SWIM PROJECT PROFILE		File No. : 23
Regist. No. : Agency No. : DPWH-33	Name: LIBASAN SWIP	
Region: 11	Province: DAVAO DEL NORTE	Municipality: NABUNTURAN
Present Status: 1. Pre-F/S( )    ② F/S(1984)    3. D/D( )		
Purpose: Major : Irrigation Incidental : IF, FC		
Project Feature:

SWIM PROJECT PROFILE		File No. : 24
Regist. No. : Agency No. : NIA-4	Name: PARPAGOJA SWIP	
Region: 4	Province: ROMBLON	Municipality: SAN ANDRES
Present Status: 1. Pre-F/S( )    ② F/S(1982)    ③ D/D( - )		
Purpose: Major : Irrigation Incidental : IF, FC, MH, WM		
Project Feature:

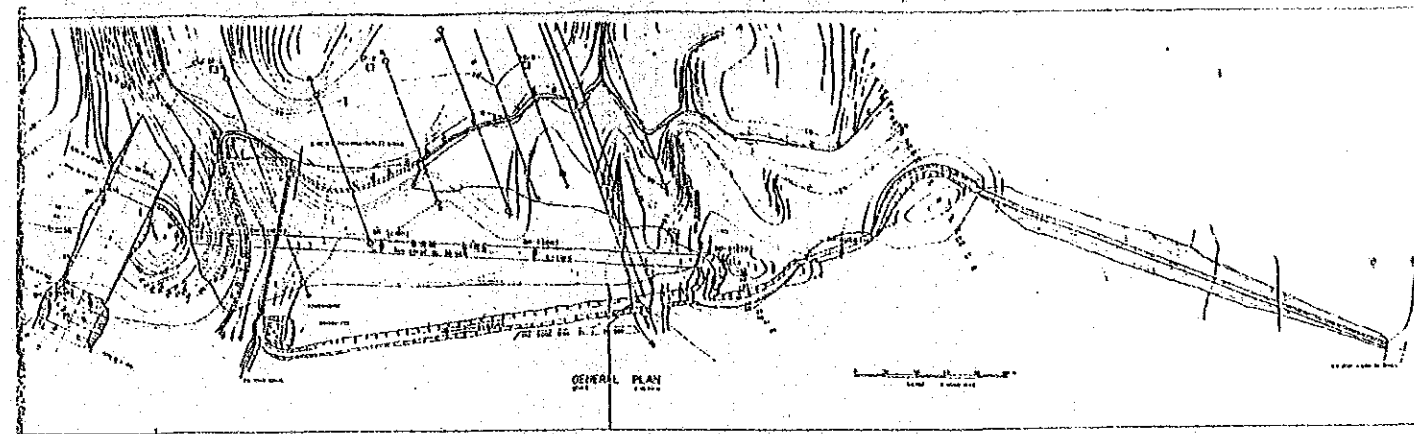
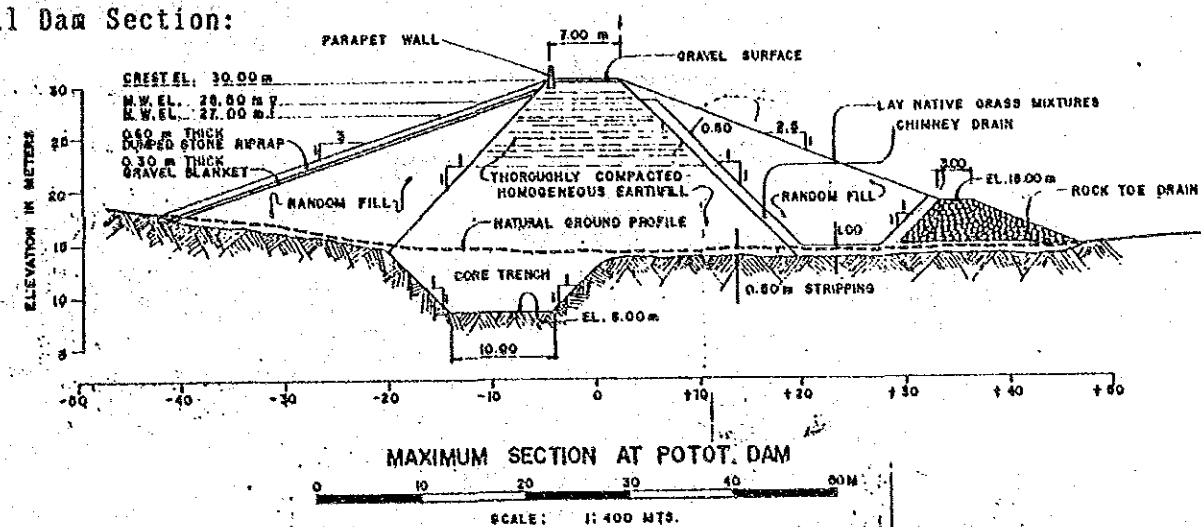
3. Design		
Excavation line of core trench shall be in clay layer.		
Weir shall be provided in the spillway.		
Inlet of outlet works is recommended to be located in outside of dam embankment.		
Design discharge for diversion works is not mentioned.		
Conduit with 0.60 m diameter for diversion works would be small.

Dam foundation is highly weathered. Additional survey on consolidation, bearing capacity and permeability for clay layer are required for final dam design.

Profile of Dam Axis:

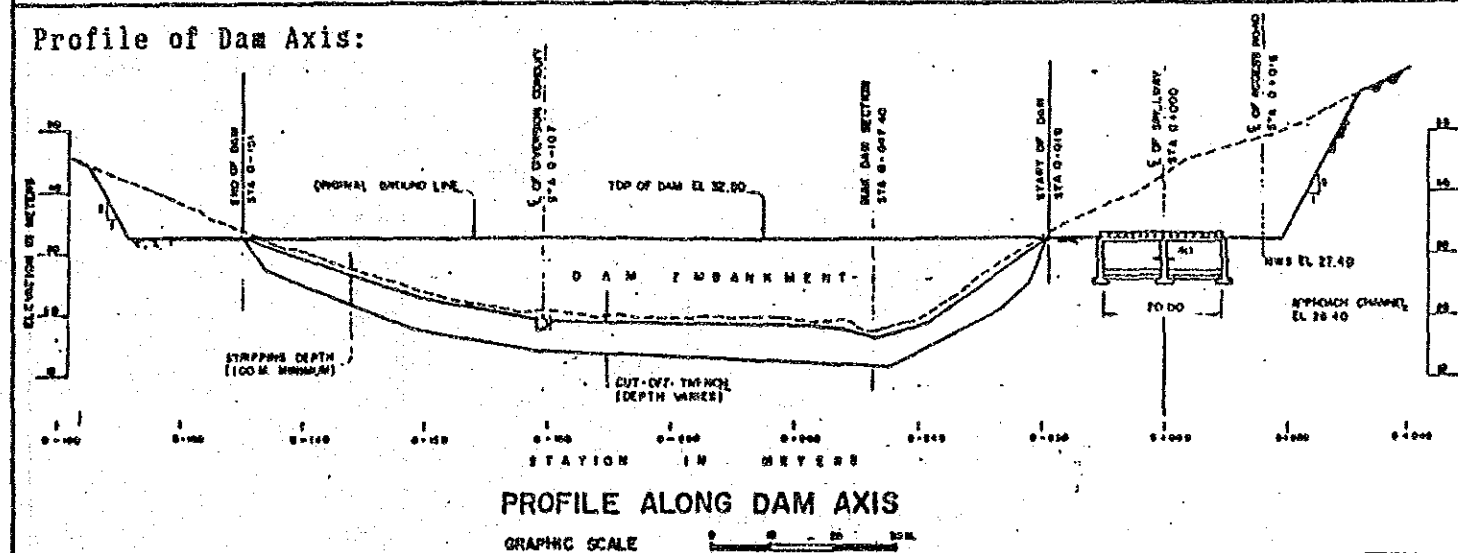
2. Planning Mini-hydro. benifit is over-setimated. Watershed management plan is not formulated.		
3. Design Design of core trench in river bed shall be determined after confirmation of deposit's extent. Inlet of outlet works is recommended to be located in outside of the dam embankment.

As to both side abutments, 0.5-1.0 m excavation is enough judging from N value. Grouting is not necessary since basic schist have been considerably weathered and no anxiety of percolation through rock crack.

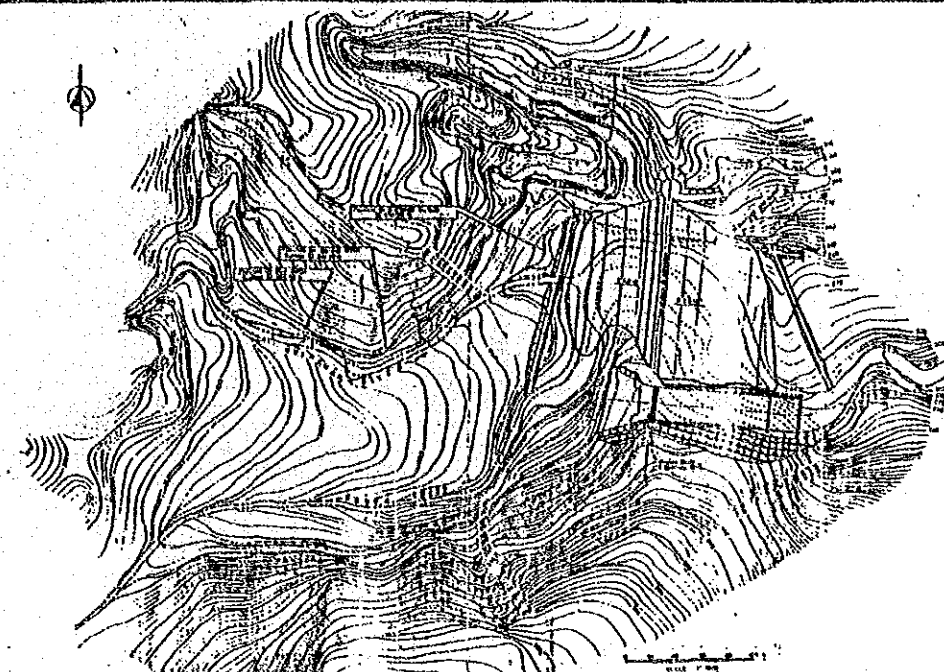
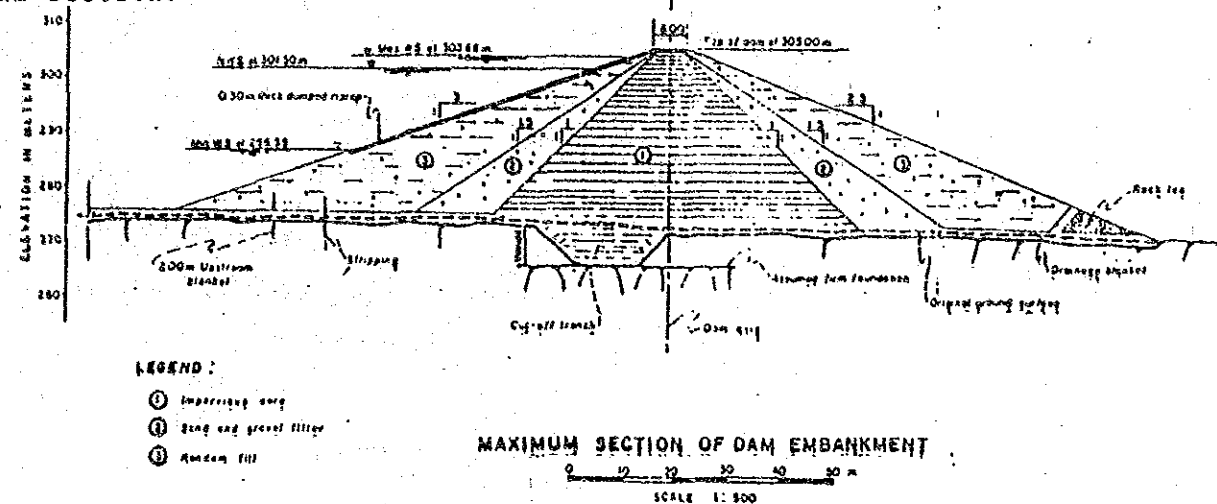
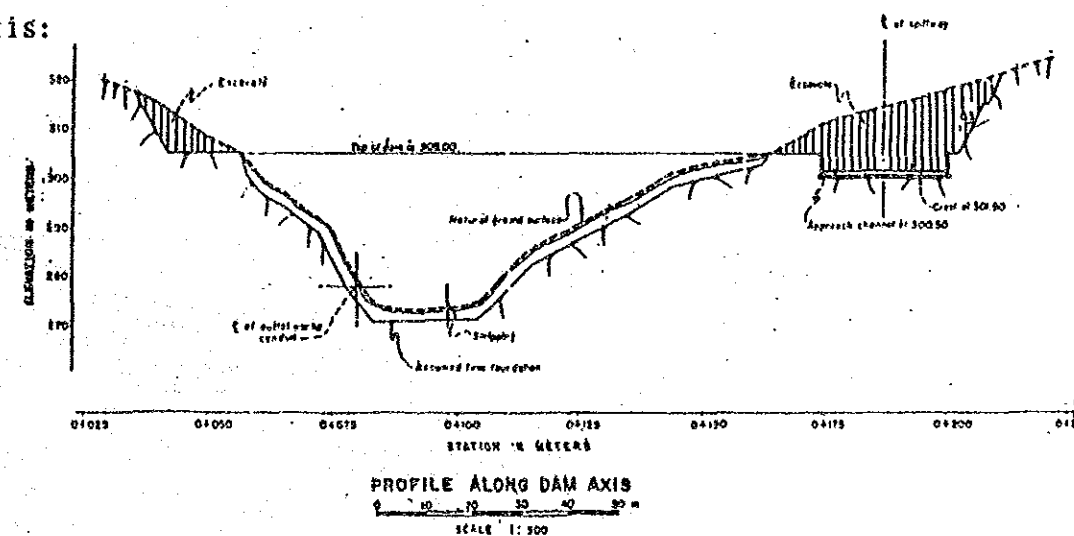
2. Planning Environmental conservation plan and watershed management plan are not formulated. Project planning shall be re-formulated.		
3. Design Grouting works under the core trench is recommended to avoid the percolation failure. Inlet of outlet works is recommended to be located in outside of dam embankment. Design discharge shall be estimated.

Treatment of the stratum's contact face in left abutment against percolation is troublesome. Method of excavating works in boulder with 10 m depth for core trench shall be well studied. (grouting area is estimated to be 6,100 m<sup>2</sup>)

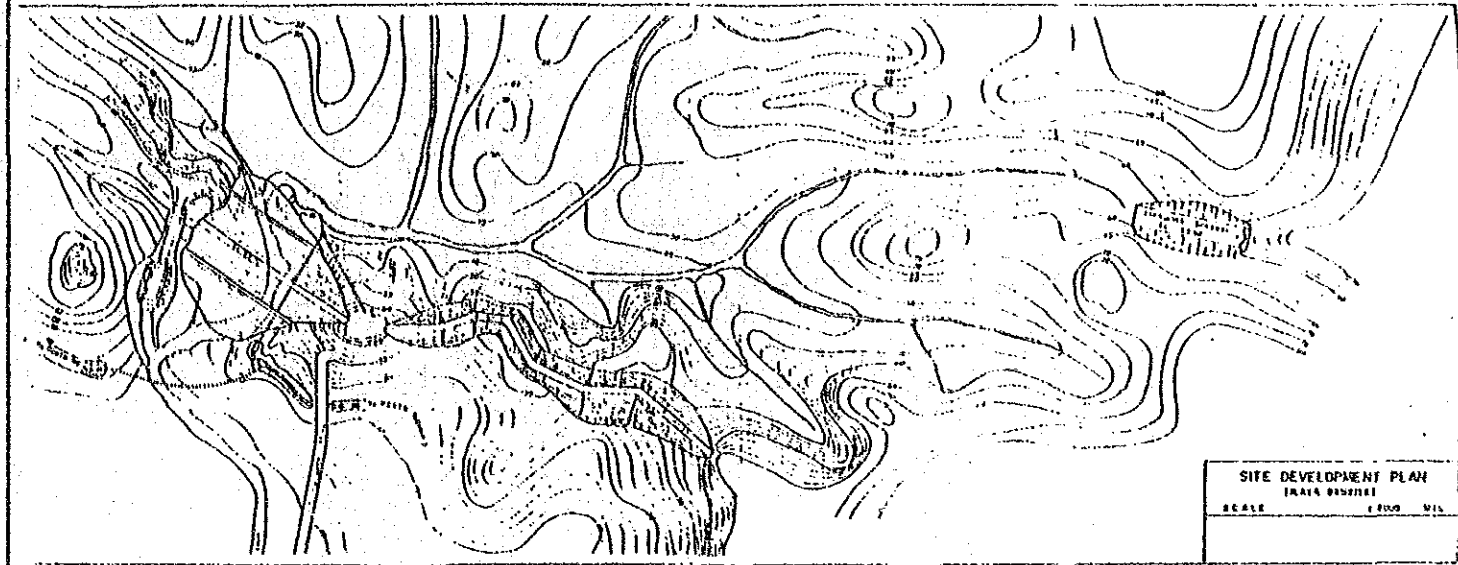
Note:  
Andesite forming the foundation is generally fractured/fragmented, but it could be estimated a good foundation for earthfill dam. Impervious blanket in the upstream side is imperative for percolation failure.

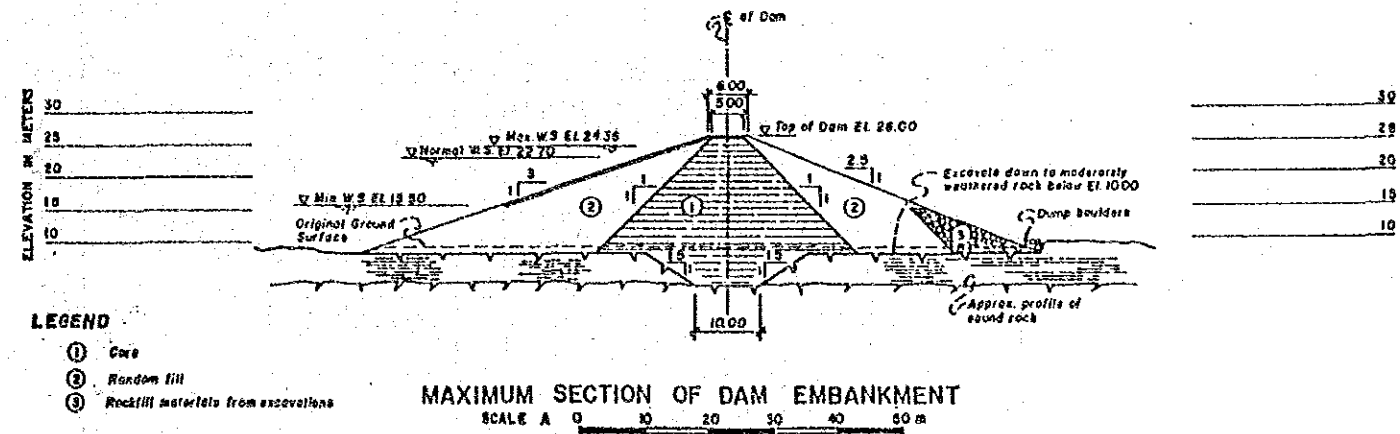
2. Planning Environmental conservation plan and watershed management plan are not formulated.		
3. Design N value is widely ranging 6-12 in the abutment. Study for sliding on the foundation shall be conducted. Compaction near the spillway shall be carefully carried out to avoid percolation failure. Inlet of outlet works is recommended to be located in outside of dam embankment.

Sliding study through the foundation is necessary in spite of low dam. Because the foundation, which are alternately layered by mud and sand stone in tertiary period are deeply weathered.

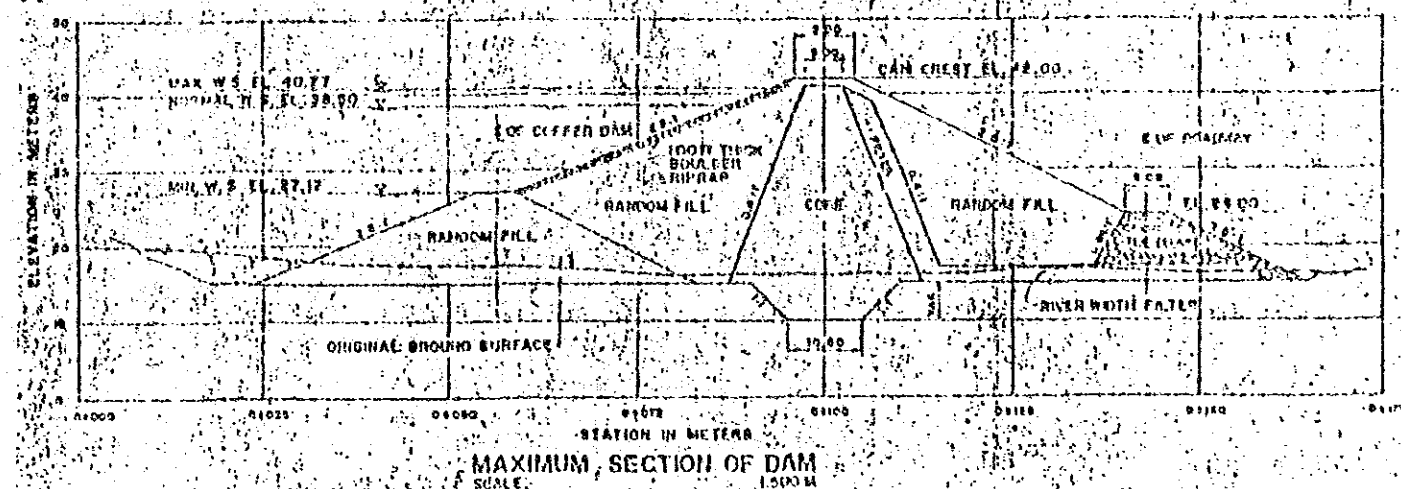
2. Planning Mini-hydro. benefit is over-estimated. Environmental conservation plan is not formulated.		
3. Design Permeability in Andesite foundation is considerably high. Grouting works is recommended for foundation treatment. Stability of the downstream slope of dam shall be checked. Width of supercritical flow section is recommended to be reduced. Inlet of outlet works is recommended to be located in outside of dam embankment.

Excavation of core trench is easy since there is a shallow river deposits. Grouting is required to decrease the percolation loss (Grouting length is about 6,630 m).

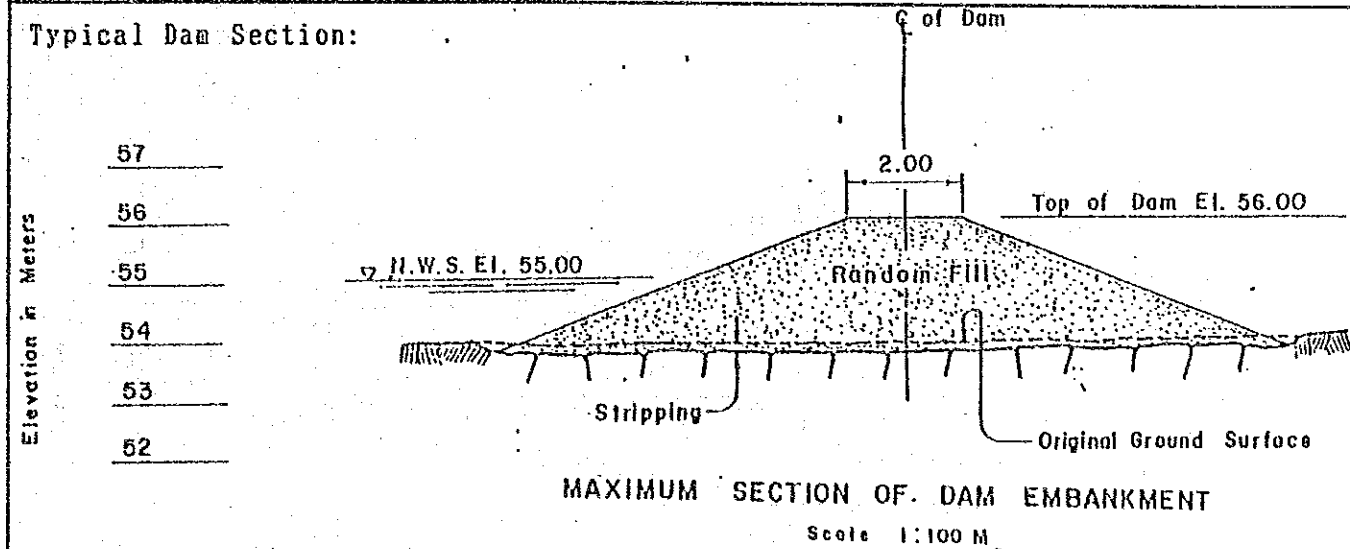
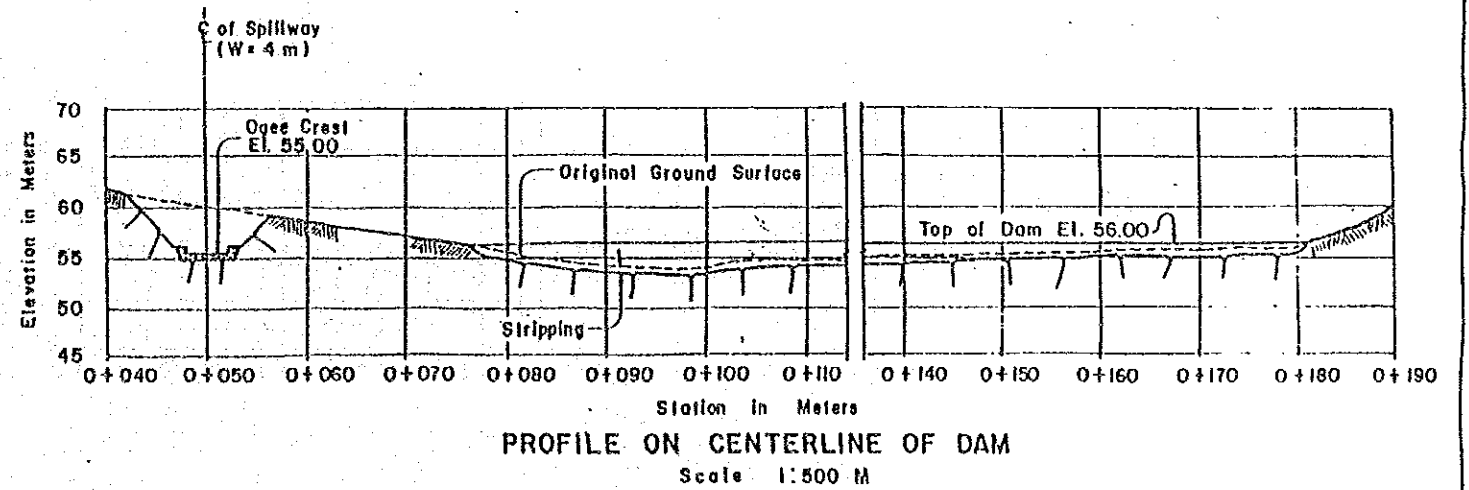
Dam configuration is reasonably proposed taking low dam into consideration. If foundation show the slightly weathered or hard rock by sub-surface exploration, concrete weir should be studied as an alternative. Combined dam with earth and concrete must be avoided. Additional 0.5 m freeboard is necessary.

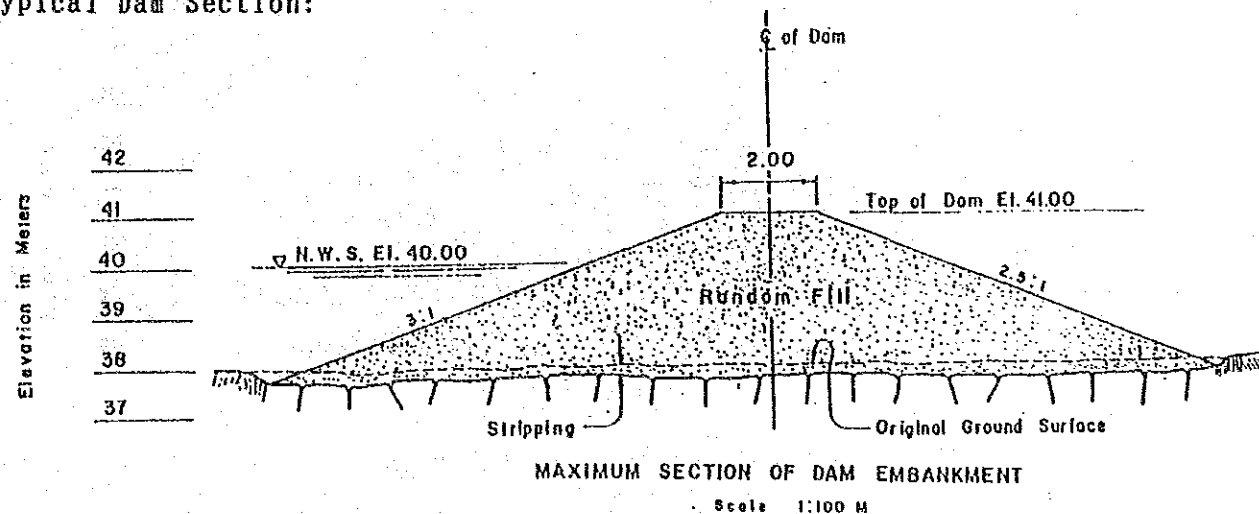
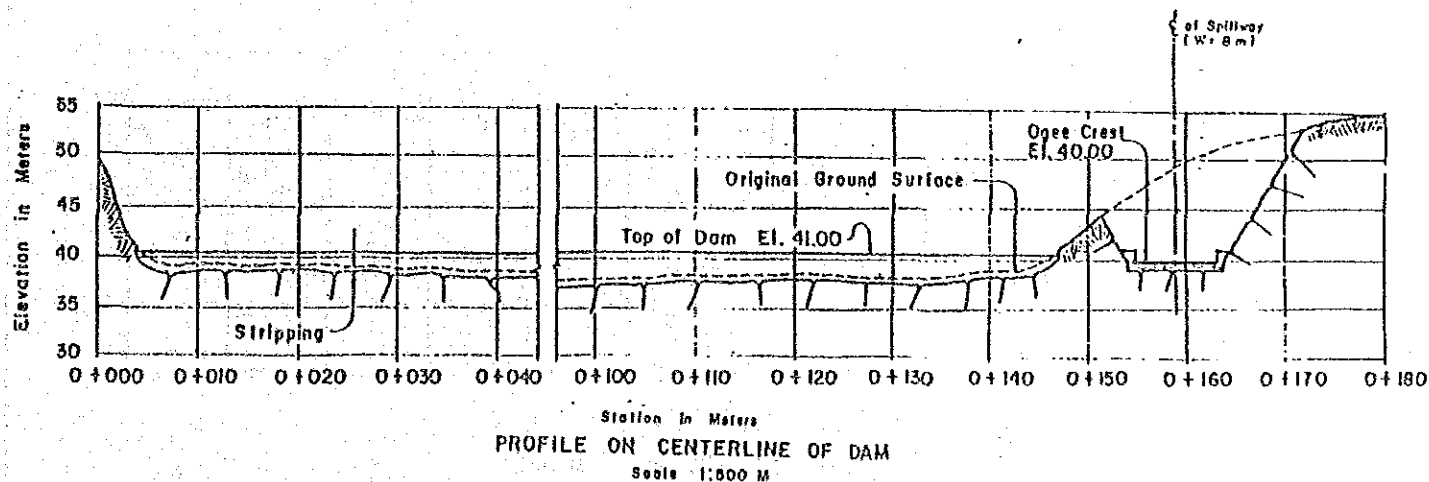
Note: Dam configuration is reasonably proposed taking low dam into consideration. If foundation show the slightly weathered or hard rock by sub-surface exploration, concrete weir should be studied as an alternative. Combined dam with earth and concrete must be avoided. Additional 0.5 m freeboard is necessary.
